Rail Coach Factory, Kapurthala

CAI No.: ED/CAI/031 Dated: 20.03.2024

Sub: Coach Alteration Instructions for modifications to be carried out Wheel Set Earthing Equipment (WSEE) to EDTS 101.

Sub: Issues regarding loosening of cover of wheel set earthing equipment .

Helicoil spring

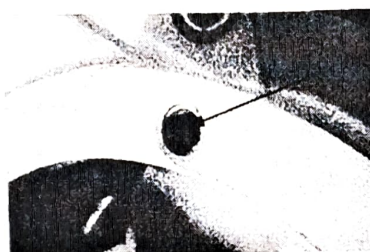
- i. Removal of the helicoil spring from the existing 03 nos. mounting holes provided in WSEE housing for fixing of front cover with special tool.

- ii. Modifying the existing 3nos. mounting holes to M12 threaded hole suitable for SS bush to drawing no. SKED 945 in housing for WSEE to Drawing no. LW71233. The PCD of 160mm at 120deg. shall be maintained to ensure proper fixing of cover during assembly.
- iii. Fixing of the threaded SS bush (AISI 304) in threaded holes with use of Loctite Red 271 Thread locker of 3M make and SS bush shall be tested for any movement during screwing and unscrewing of M8 Stud after the specified period of 30min (min).

Mounting bolts

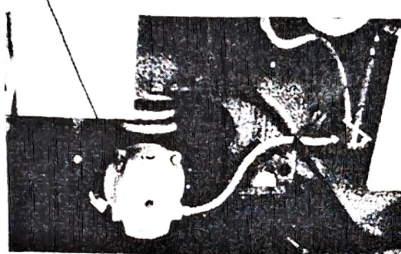
- Disconnecting the earthing cable to drawing No. LW71245 Alt.-'d' from Bogie to WSEE by removing hardware.
- Unfastening of mounting bolts M16X45mm of earthing device housing from bogie axle in order to dismantle the WSEE from bogie axle.
